SUBJECT: POINT BEACH NUCLEAR PLANT, UNIT NOS. 1 AND 2 - ISSUANCE OF  
AMENDMENTS FOR TECHNICAL SPECIFICATION CHANGE REQUESTS 188 AND 189  
(TAC NOS. M95682, M95683, M95697, AND M95698)

POINT BEACH NUCLEAR PLANT, UNIT NO. 1

Amendment No. 173  
License No. DPR-24

ATTACHMENT TO LICENSE AMENDMENT NOS. 173 AND 177  
TO FACILITY OPERATING LICENSE NOS. DPR-24 AND DPR-27  
DOCKET NOS. 50-266 AND 50-301

Figure 15.2.1-1  
 POINT BEACH NUCLEAR PLANT UNITS 1 AND 2\*  
 REACTOR CORE SAFETY LIMITS

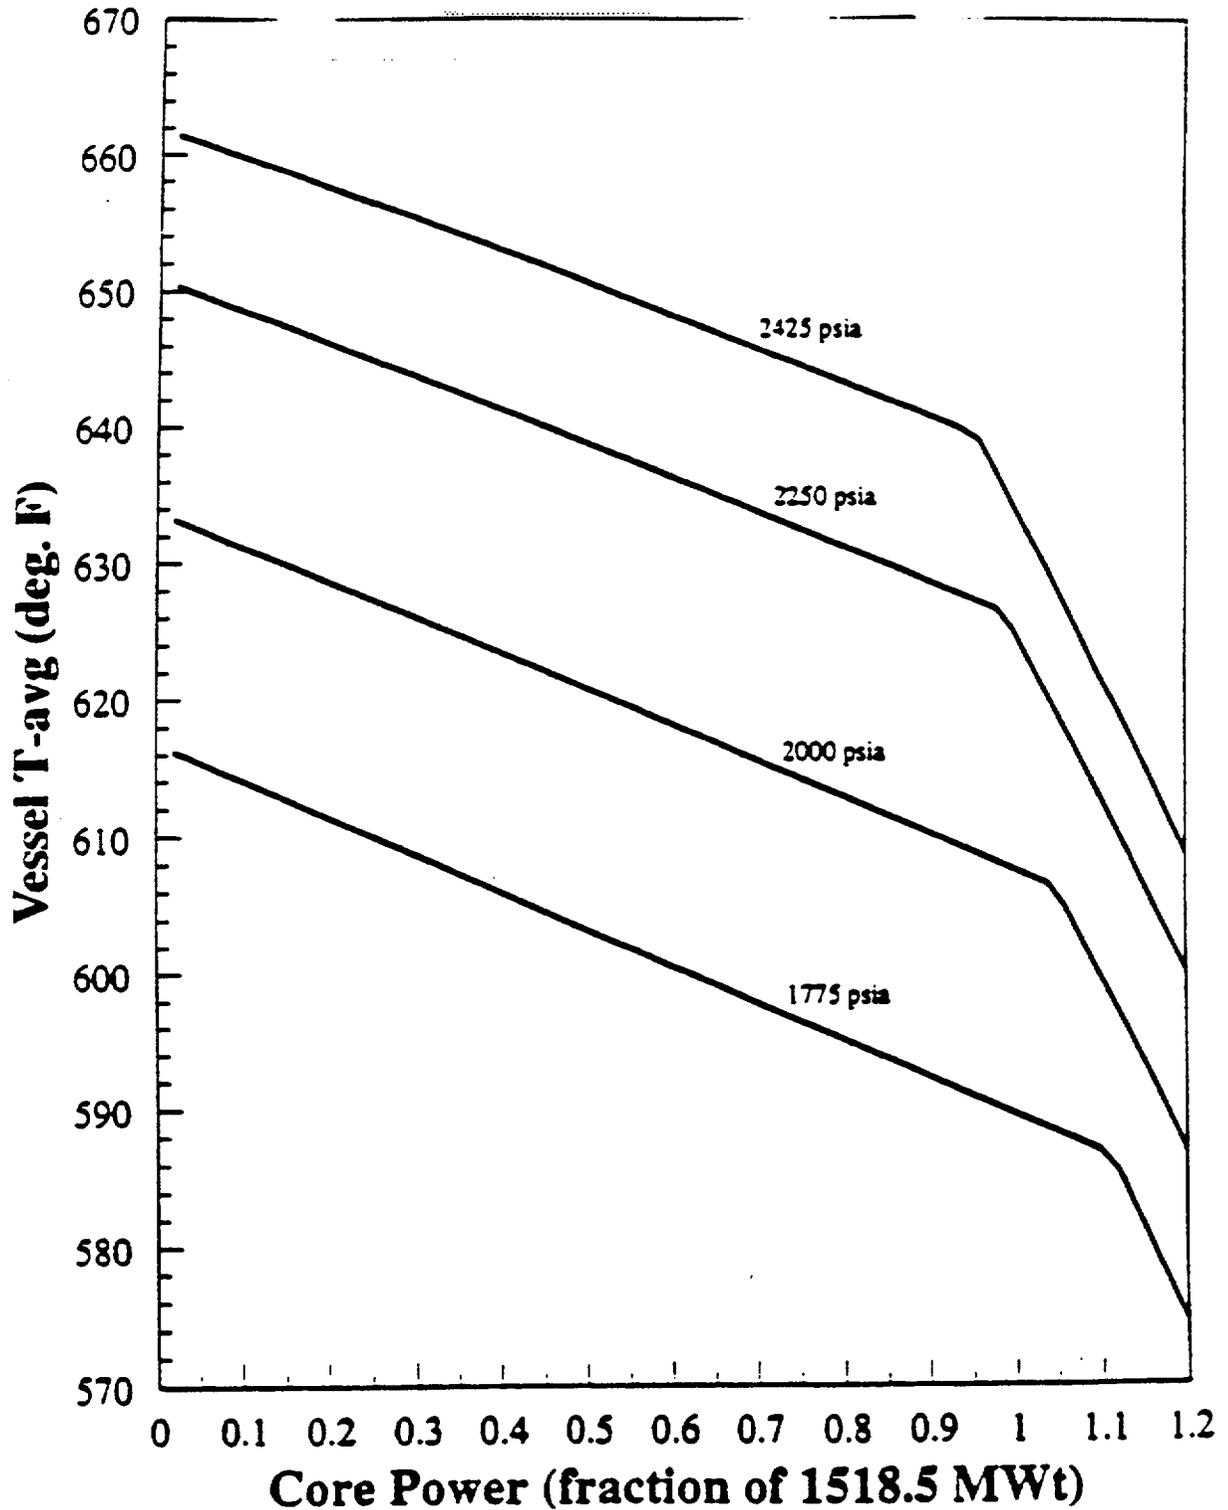
\* This figure applies to Unit 2 following U2R22 and to Unit 1 following U1R24. Prior to U1R24, Figure 15.2.1-2 applies to Unit 1.

Figures 15.2.1-1 and 15.2.1-2: Combine Figures 15.2.1-1 and 15.2.1-2 into a revised Figure 15.2.1-1, renumber existing Figure 15.2.1-1 as 15.2.1-2, and add a footnote to each figure concerning the applicability of the figures to each unit.

The Unit 2 change will be made immediately. However, in order to avoid the possibility of an inadvertent reactor trip, Unit 1 will continue to operate with the existing safety limit values until the 1997 fall refueling outage (R24). Therefore, a footnote will be added to the appropriate TS to clarify that Figure 15.2.1-1 applies to Unit 2 following U2R22 and to Unit 1 following U1R24. Prior to U1R24, revised Figure 15.2.1-2 applies to Unit 1.

Figure 15.2.1-2\*  
 REACTOR CORE SAFETY LIMITS  
 POINT BEACH UNIT 1

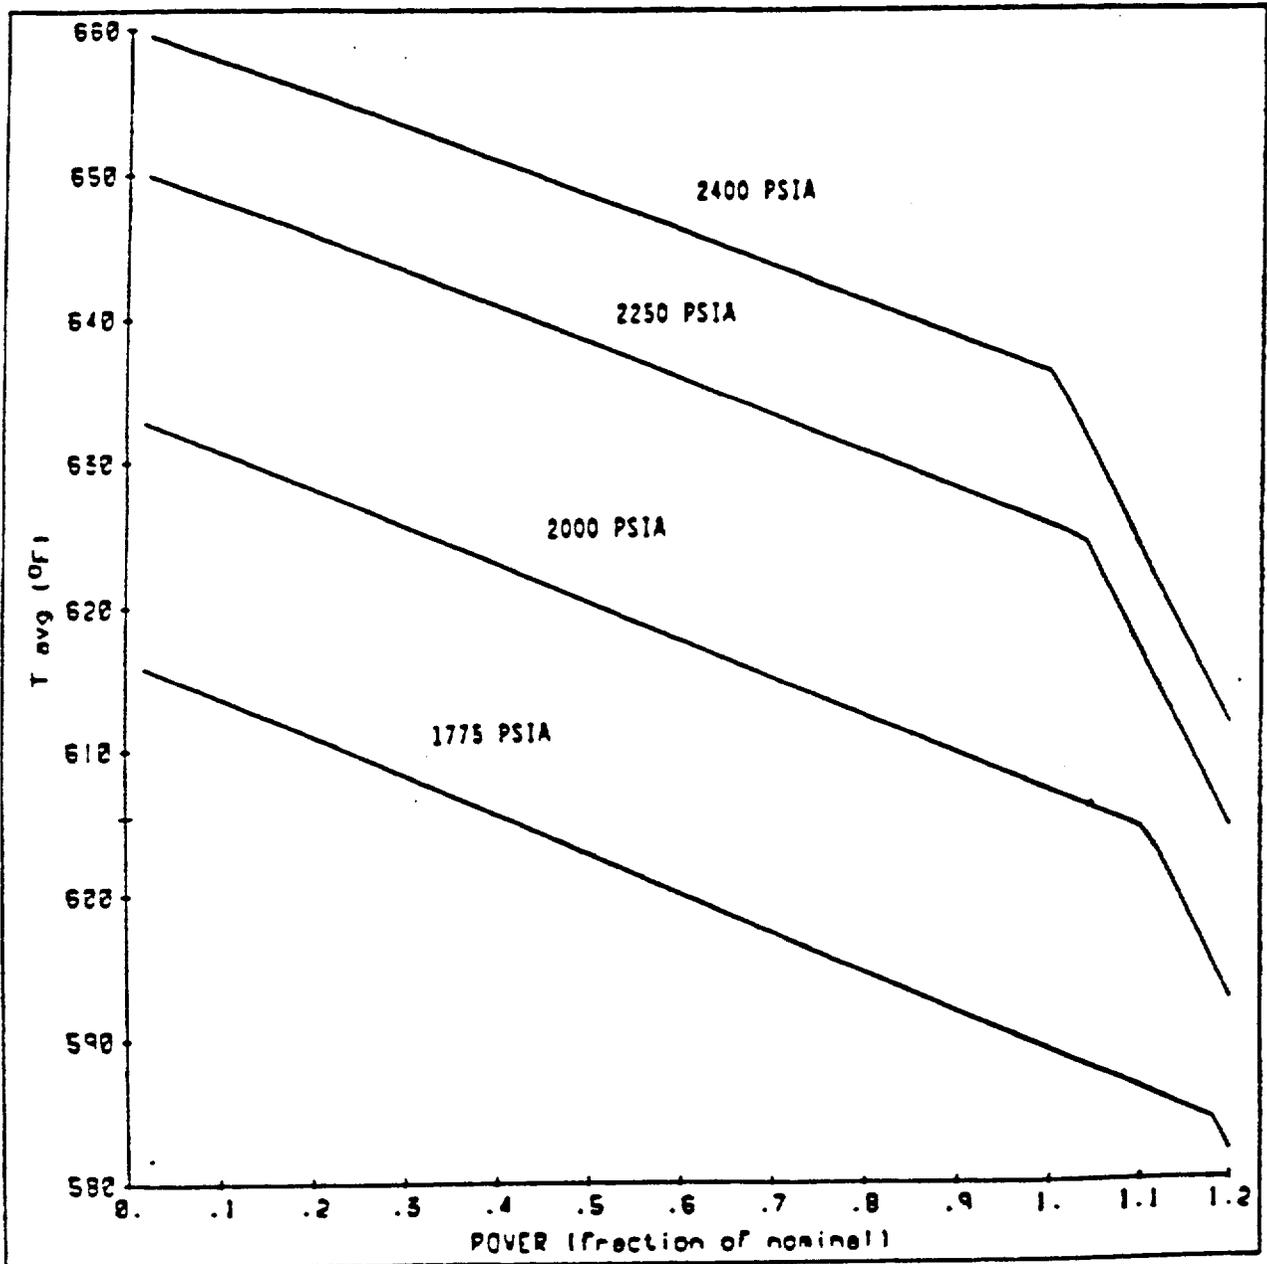
\* This figure applies to Unit 1 prior to U1R24. Following U1R24, Figure 15.2.1-1 applies to Unit 1.

FIGURE 15.3.1-5

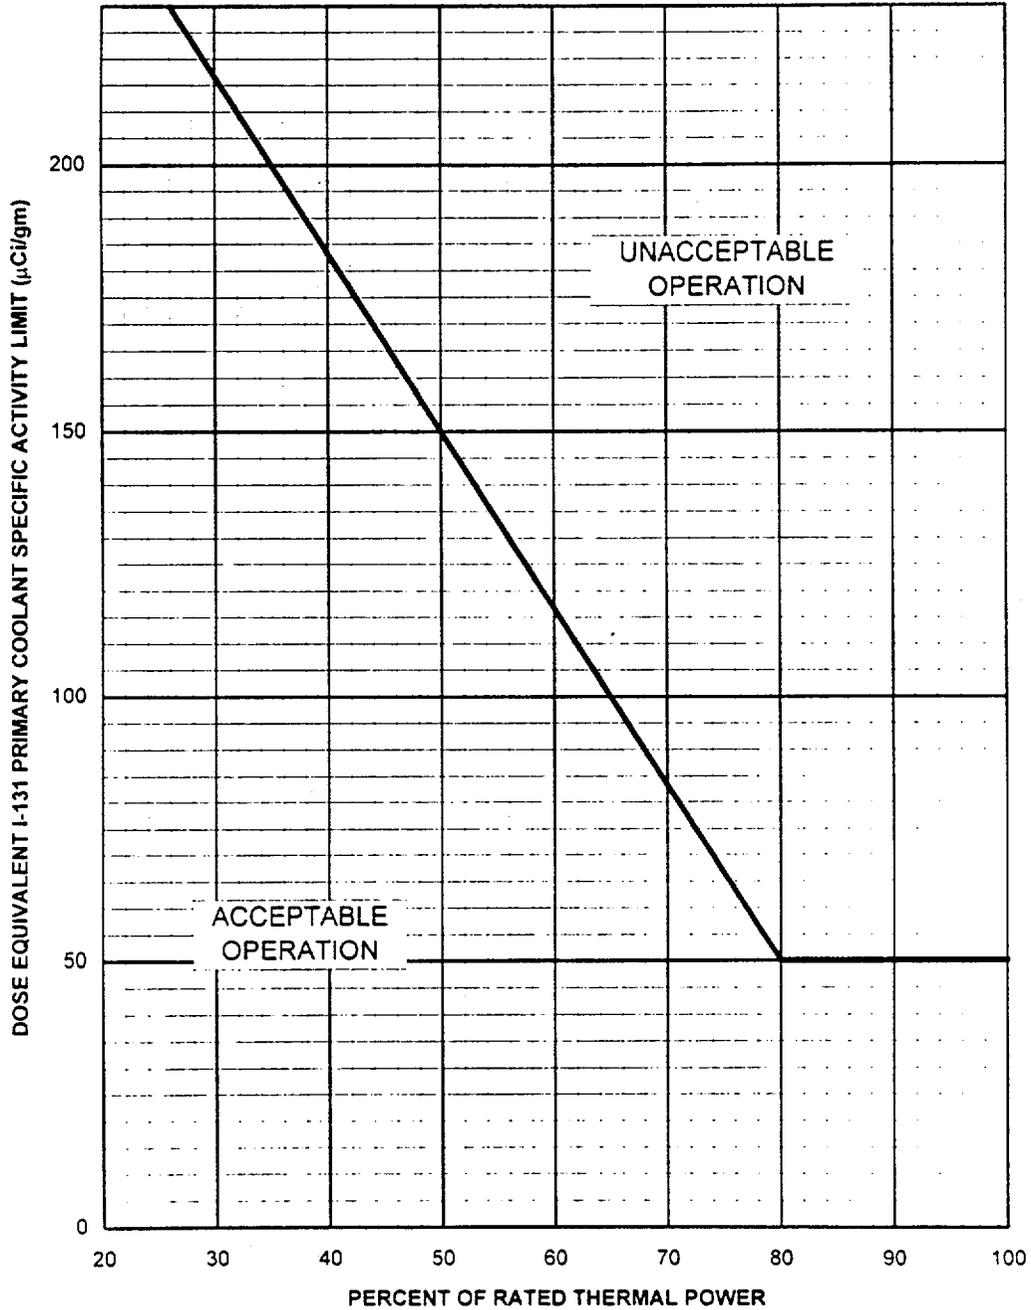
- i. TS 15.1, "Definitions;" TS 15.3.1, "Reactor Coolant System," Section C, "Maximum Coolant Activity," which includes Figure 15.3.15, "TS 15.3.4, "Steam and Power Conversion System;" TS 15.4.1, "Operational Safety Review;" and TS 15.6.9, "Plant Reporting Requirements" (pages 15.1-6, 15.3.1-9, 15.3.1-10, 15.3.4-2, 15.3.4-3, 15.6.9-3, Figure 15.3.1-5, Table 15.3.5-1 (page 1 of 2), and Table 15.4.1-2 (pages 1 and 2 of 5)): Revise the definition of Dose Equivalent I-131 from Table III of TID-14844, "Calculation of Distance Factors for Power and Test Reactor Sites," to Table 2.1 of Federal Guidance Report No. 11, "Limiting Values of Radionuclide Intake and Air Concentration and Dose Conversion Factors for Inhalation, Submersion, and Ingestion," dated September 1988.

Revise the limits of RCS specific activity from 1.0 to 0.8 microcurie per gram Dose Equivalent I-131 and secondary steam generator coolant specific activity from 1.2 microcuries per cubic centimeter to 1.0 microcurie per gram Dose Equivalent I-131.

The proposed TS changes will revise the limits of RCS specific activity to 0.8 microcurie per gram Dose Equivalent I-131 and revise the secondary side steam generator dose equivalent I-131 activity to 1.0 microcurie per gram. The licensee proposes to use the dose equivalent I-131 defined in Table 2.1 of Federal Guidance Report No. 11, "Limiting Values of Radionuclide Intake and Air Concentration and Dose Conversion Factors for Inhalation, Submersion, and Ingestion," dated September 1988. The proposed change ensures consistency between the TS and new radiological analyses. The effect of this change causes the Dose Equivalent I-131 limit to be reduced by 20 percent.

The staff finds the proposed changes acceptable since the net effect of both the change in limits and the change in the standard result in equivalent doses consequences.
